National Electrical Safety Code

Interpretations

1984 — 1987 inclusive

National Electrical Safety Code Interpretations

TYPICAL LOOP PROBLEMS
Fig IR 392-1

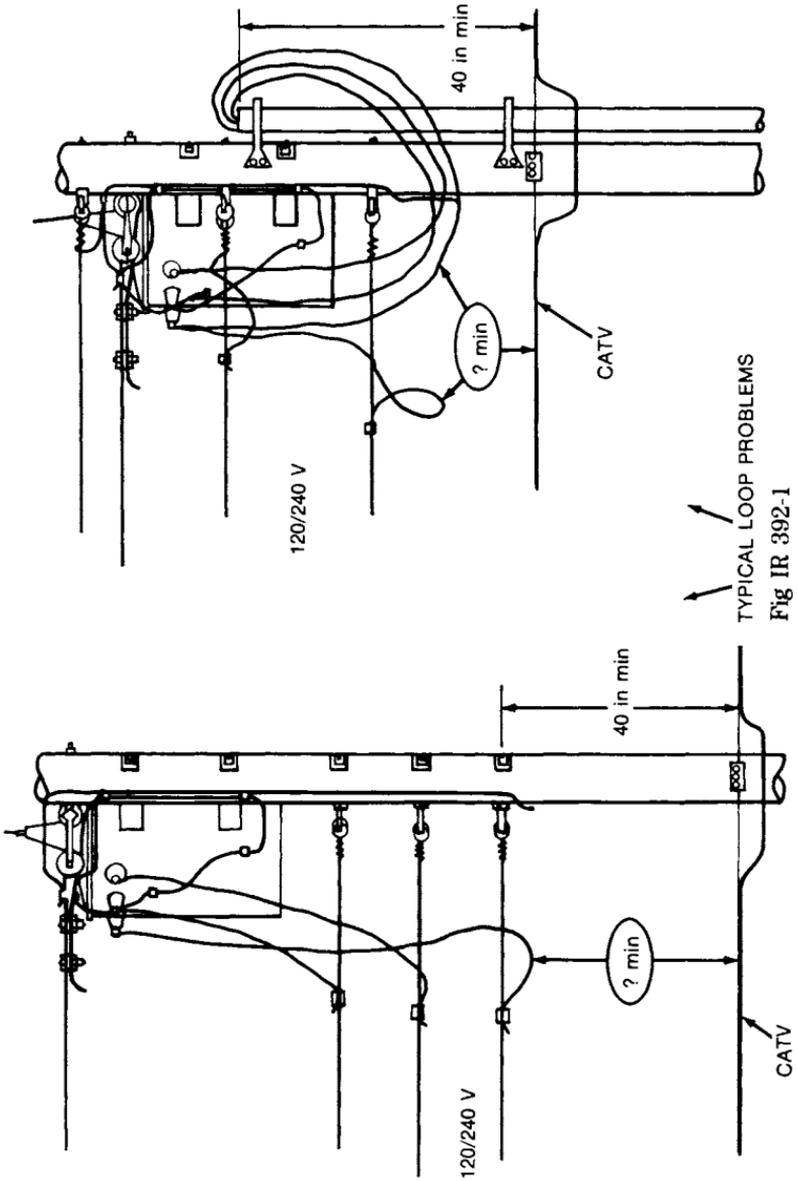
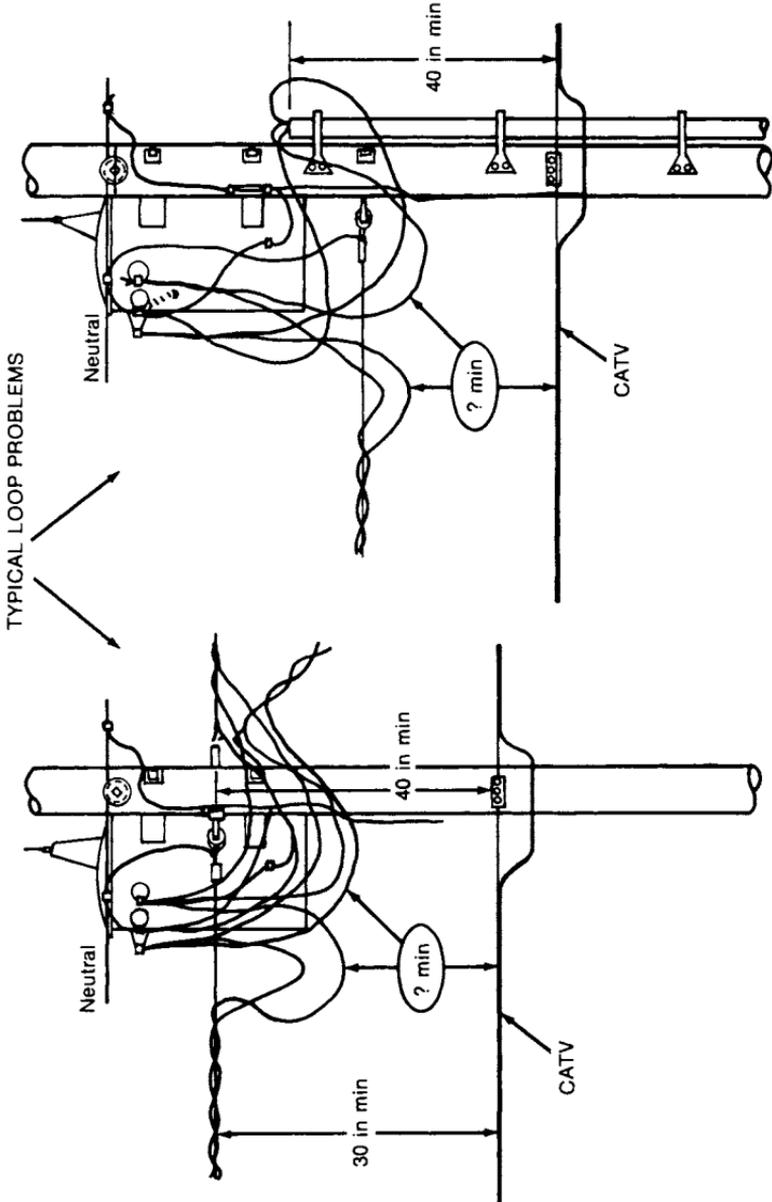
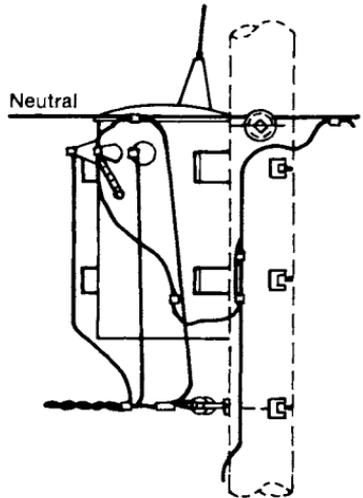
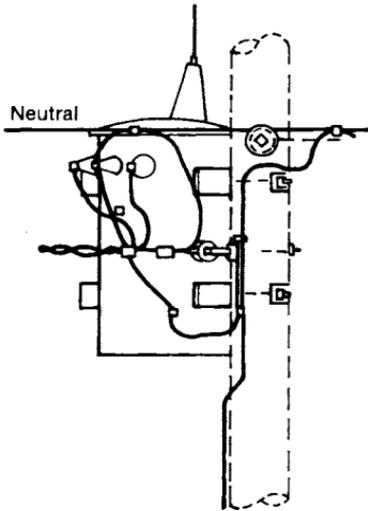
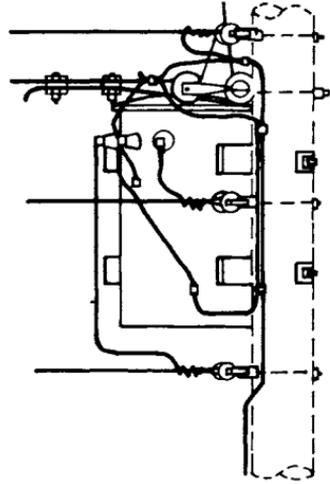
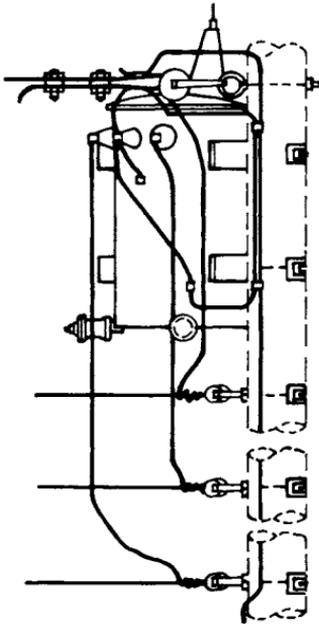
We request an interpretation regarding Rule 235C2b(1)(a), which deals with conductors of different sags on the same support. In particular, are the "drip loops" or "slack" cables from an aerially-mounted transformer a part of the span? A conflict of interpretation has arisen between an electric utility and the cable television company over the clearance between secondary cables (120/240 V) after they leave the point of pole attachment and connect to the transformer lugs. We understand the minimum vertical clearance to be 40 in between the cable television attachment and the secondary conductor attachment as reflected in Rule 235C, Table 235-5. Please comment on the status of the drip loops in question. Figures IR 392-1 and IR 392-2 are drawings of typical problems we have observed in this matter.

The answer to IR 388 applies to this question. See Rules 238A, B, Rule 238D does not apply in this case.

Fig IR 393-1

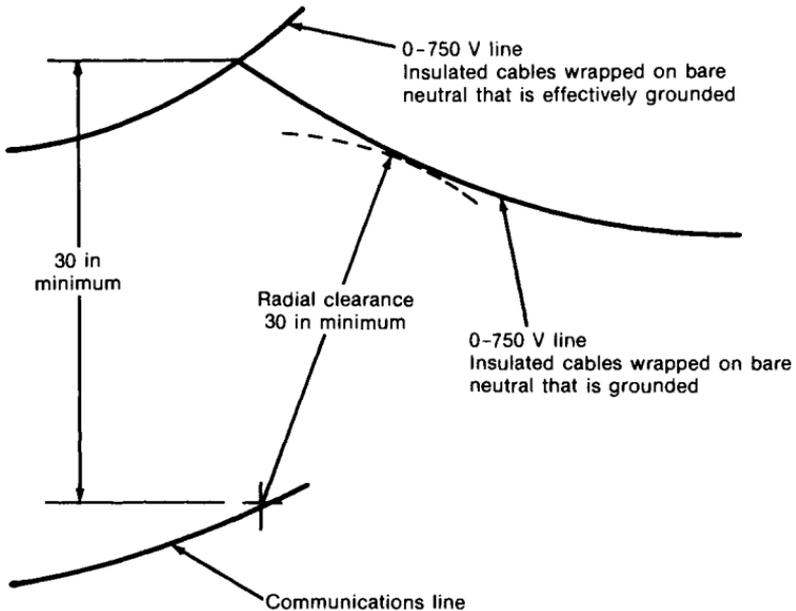
A secondary line of 0-750 V is strung between two poles and attached a minimum of 40 in above a communication circuit at the pole. There is a service line attached at midspan. The minimum clearance between the secondary line and the communication line is 30 in after the service is installed. Please provide interpretations of the following questions (see Fig 393-1):

- (1) Is the radial clearance of 30 in the proper method and dimension to use for measuring the clearances from the communications line?
- (2) If a communication service were installed directly below the electric service would the method or dimension change?

Fig IR 374-1
Diagram A

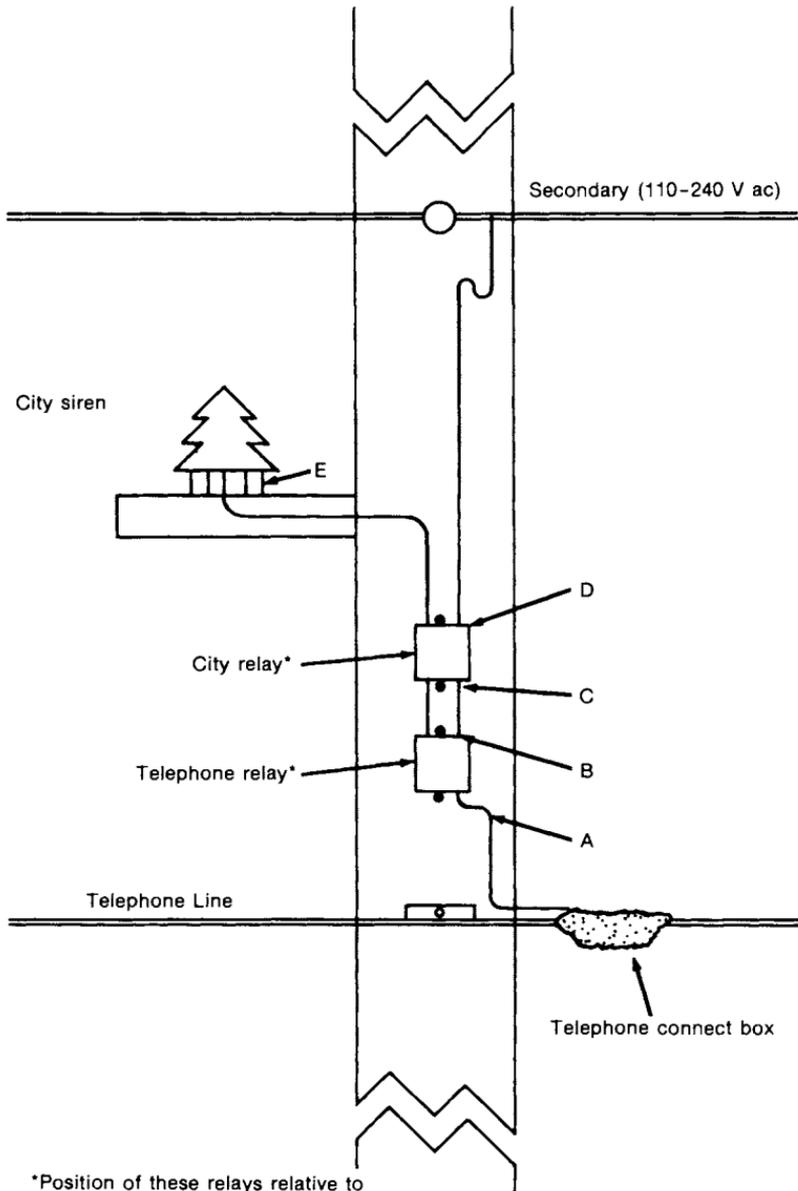
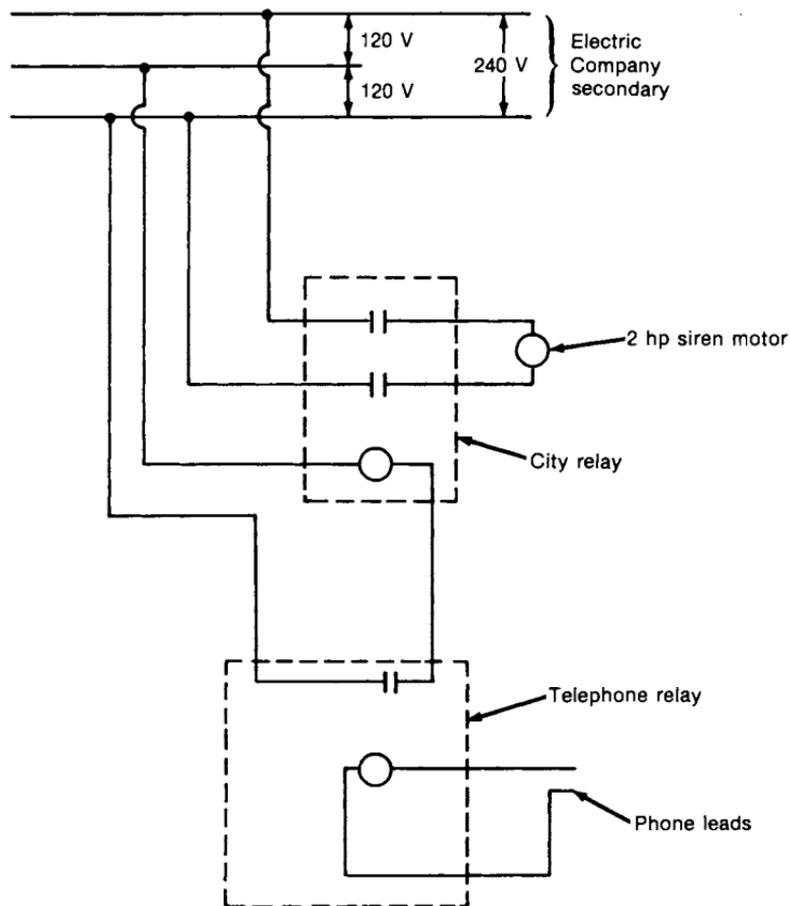
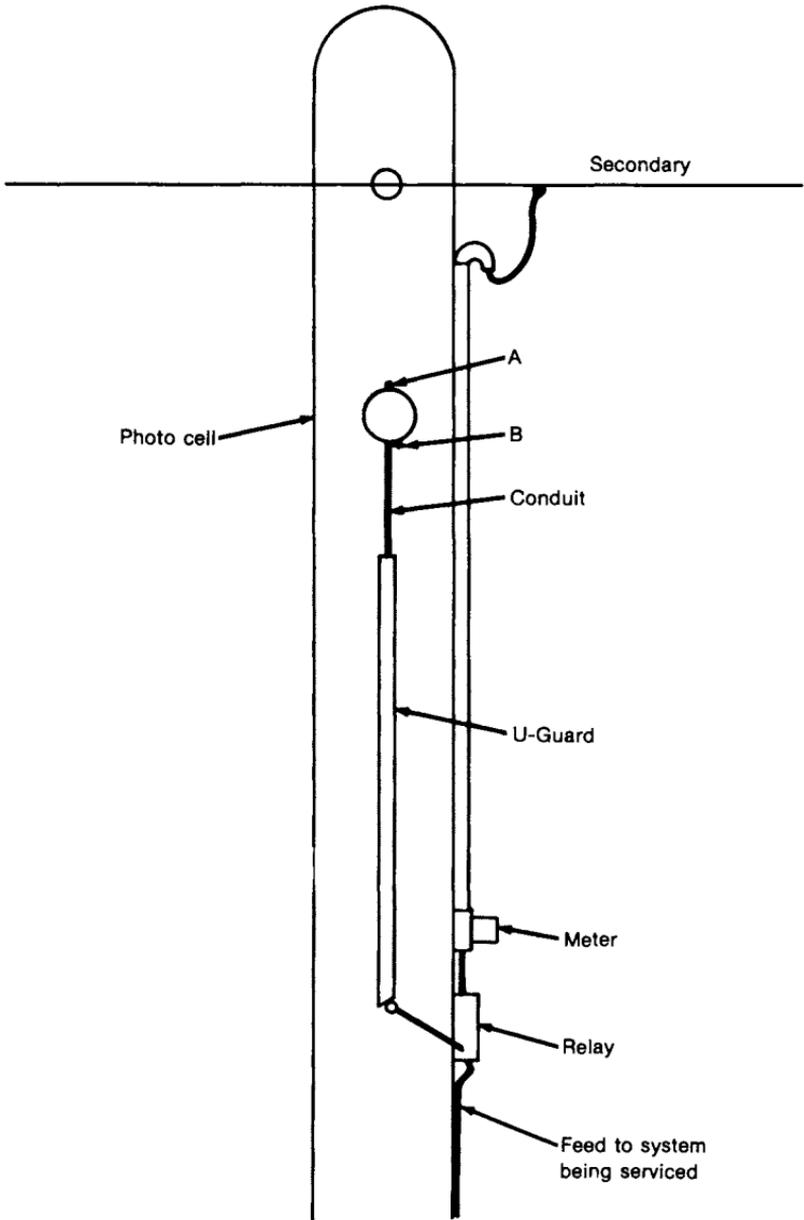
Figures IR 374-1-7 are depictions of two situations in diagrams, schematics, and photographs for your interpretation as to required vertical frame clearance from CATV plant.

Situation A, Figs IR 374-1-4, is a typical municipal siren and relay setup. The photographs illustrate the interchangeability of the position of the three component parts relative to each other on the pole. The schematic diagram indicates the presence of secondary voltage at both the city and telephone relays. The vertical clearances in question are those below point A, above B, below C, above D, and below E.

Situation B, Figs IR 374-5-7, is a photoreceptor that triggers services for a private concern (parking lot lights). The clearances in question are those above and below points A and B.

The difference in agreement prompting this inquiry lies in the distinction between "supply equipment" and "service equipment." Supply equipment, such as capacitor switches and meters on poles, is owned and operated by the power company. Service equipment, in this case sirens and photocells, is supplied electrically by the power company but owned and operated by municipal and private concerns. One party contends that Rule 238 applies to supply equipment only. The other denies this distinction applies.

Does Rule 238 apply to "service equipment" as described above, as well as to "supply equipment"? If it does not, does another Rule apply to "service equipment"?

Fig IR 388-1

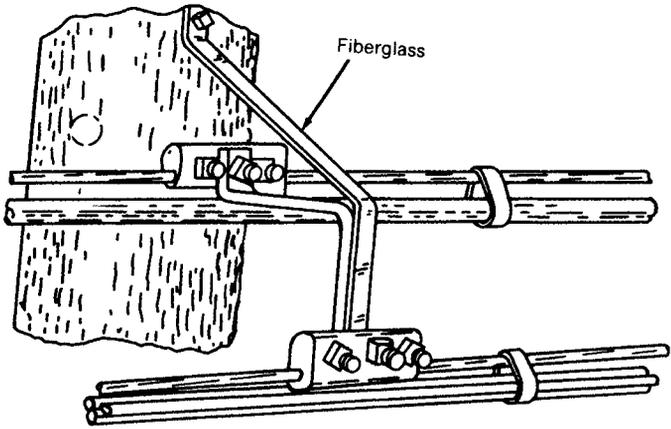
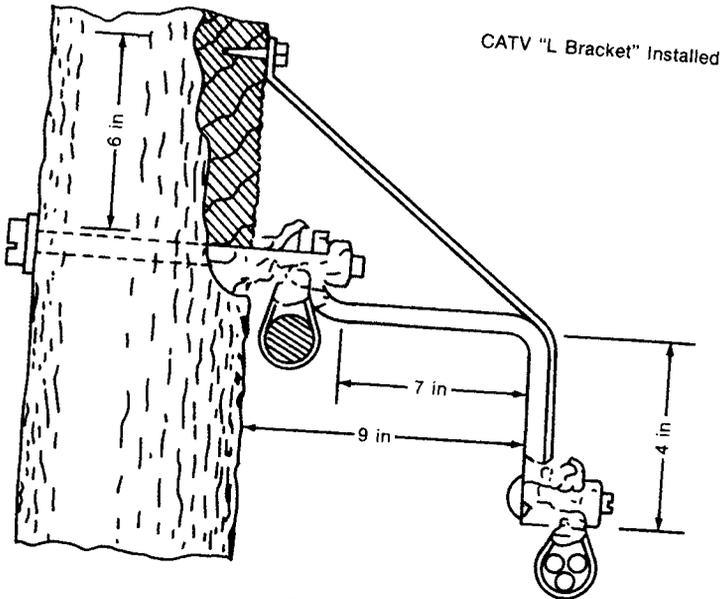
The CATV bracket with which I am concerned is shown in Fig IR 388. The reinforcing strap, which extends only 6 in into the clearance space, is fabricated of non-conductive fiberglass. Since it is affixed to the communication pole attachment, its depth of penetration into the clearance space is of necessity limited. The projected length of the strap is only about 12 in. Obviously this strap can be installed from the same position that the craftsman would be in to do his routine work on communications plant, and for this reason I believe it can be safely installed by a communications worker.

Am I correct in my opinion that communications workers can safely make the installation because of the significant differences between it and the tubular extension arm?

It is intended that no communication equipment such as described in your interpretation request be installed closer than 40 in measured vertically to an ungrounded supply conductor or part. It is vital to the safety of communication line workers to provide adequate headroom for their work. Experience has shown that, just because such a bracket can be installed from a lower position, it does not follow that the bracket will always be installed from the lower position. In fact, it could be expected that a worker might go up each pole to preinstall the brackets before pulling the cable; in that case, the worker might be expected to go up as high as would make installing the bracket the most comfortable—ie, too high if the clearances required by Rule 238B are not met in full. Therefore, the full 40 in is needed vertically below the level of any ungrounded supply conductors to the level of any communication equipment, including the bracket that you described.

Fig IR 387

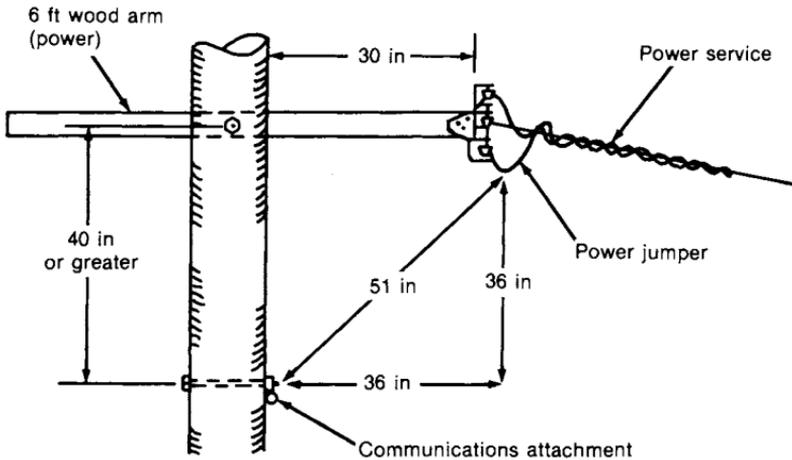
Please provide an interpretation of the applicability of NESC Rule 238B to the utility pole construction shown in Fig IR 387. The sketch shows typical construction, which would seem to satisfy NESC requirements on vertical separation of communication and power attachments as specified in Rule 235C, and also the requirements for climbing and working space specified in Sections 236 and 237.

The question arises whether Rule 238B, requiring 40 in of vertical space between power and communications conductors, would in fact apply in this case between the lowest power jumper off the arm end rack and the communications cable at the pole. Typically, in this area, the length of the jumpers below the end rack vary from 2 in to 18 in and are usually #4 to #1/0 solid aluminum or #6 solid copper that would not be prone to appreciable movement in the wind.

If Rule 238B does apply here, where the jumpers are 36 in horizontally off the pole, at what point (4 ft, 6 ft, 8 ft, 10 ft, etc), would the rule no longer apply?

Fig IR 363-1

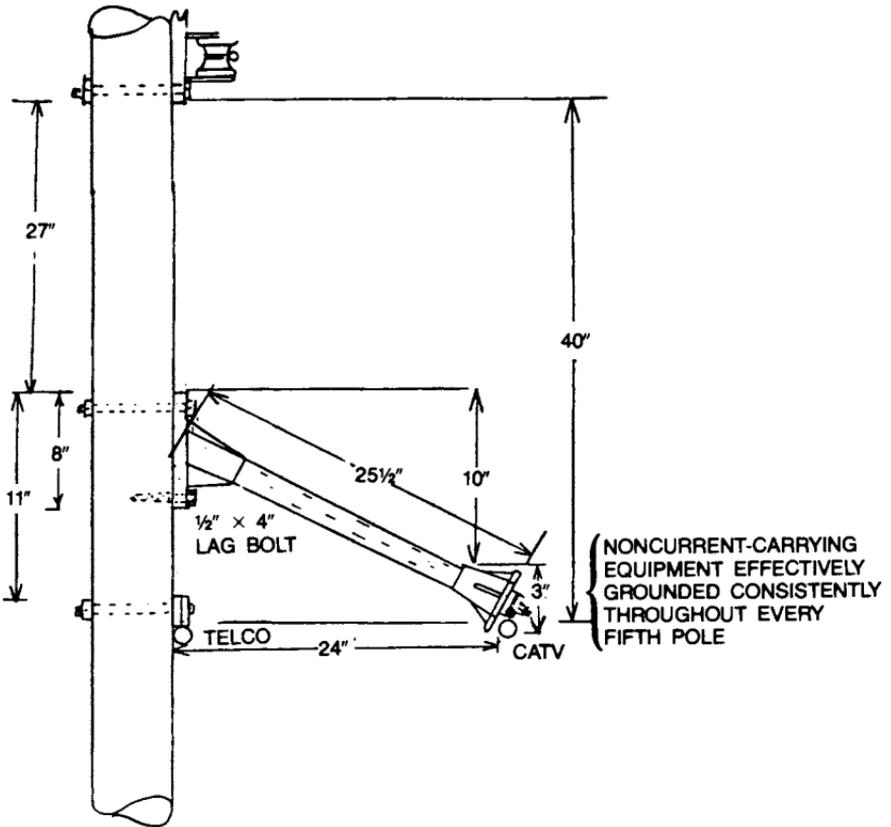
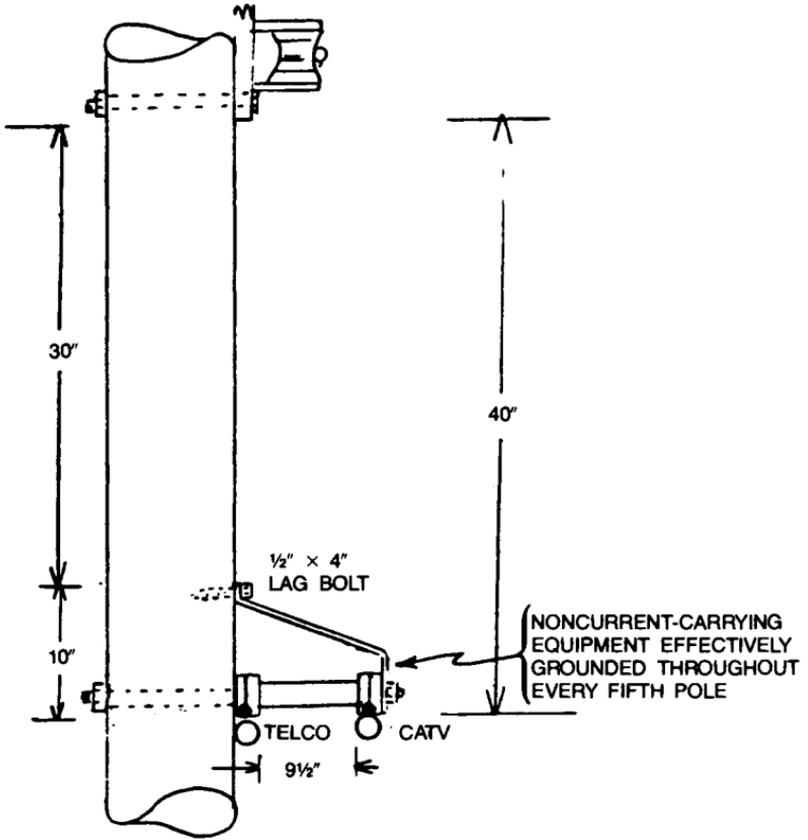
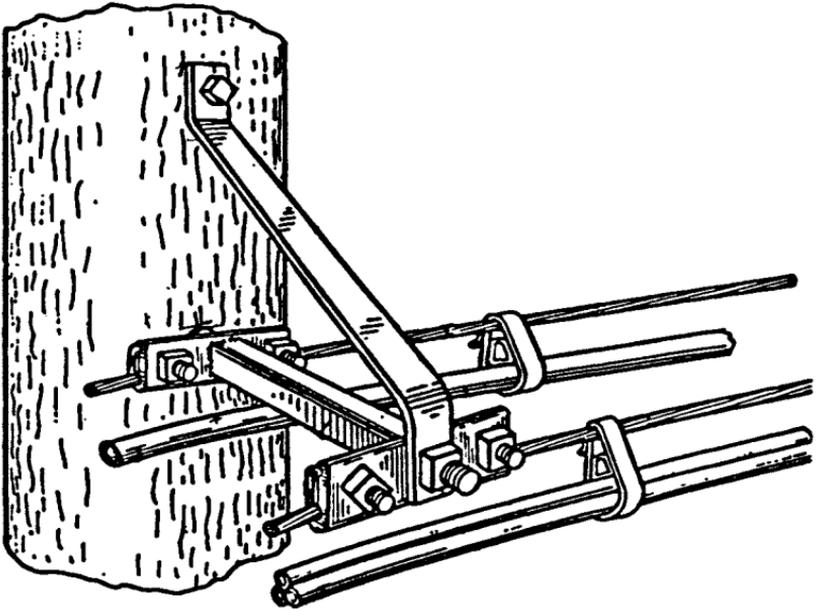
Definition of Effectively Grounded—Intentionally connected to earth through a grounded connection or connections of sufficiently low impedance and having sufficient current-carrying capacity to prevent the build-up of voltage that may result in undue hazard to connecting equipment, or to persons.

By using the above definitions, the CATV company will ground the CATV system every fifth pole in its entire system.

No specific definition of “well-defined area” is included within the Code; the answer depends upon the knowledge of the personnel of all parties concerned with the installations. The area could be a political subdivision, such as a town, township, county, or state, or a system boundary, terrain boundary, or any boundary known to all personnel involved with the installations therein. The key is that the grounding must be performed consistently throughout the area that the limits of the area must be known to all parties so that there is no uncertainty involved.
